Environmental Review Team Report

Hilltop Estates

Waterford, Connecticut

September 1980

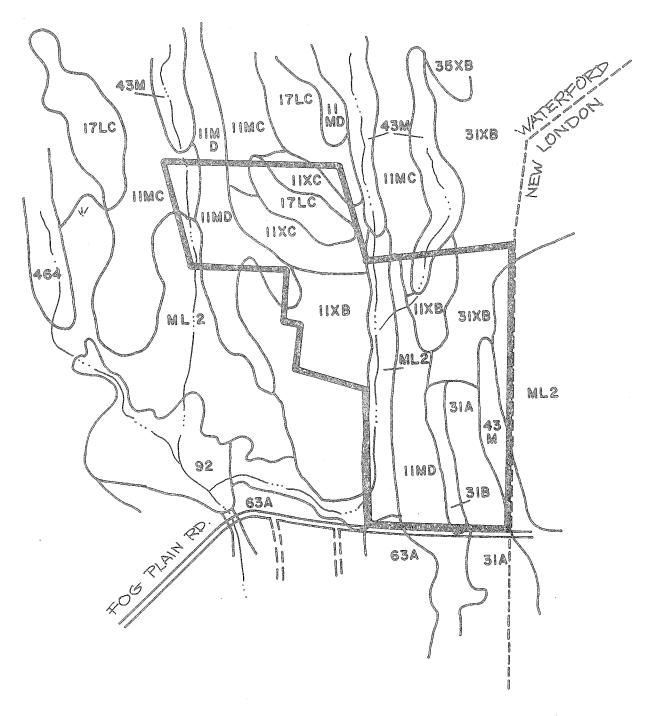
Access to the site is from Fog Plain Road. This road has both a horizontal and vertical curve in the vicinity of this site. Right angle road access should be made directly across from Clark Lane if enough land for a right of way is available or could be made available at the eastern border. This would provide a good location for a future traffic light and could also serve as an eventual extention of Clark Lane, north to the vicinity of Routes 85 and 95.

Long deadend streets on the site could be avoided in part by using the old east-west farm road and connecting it to Michael and Anthony Streets in New London immediately to the east.
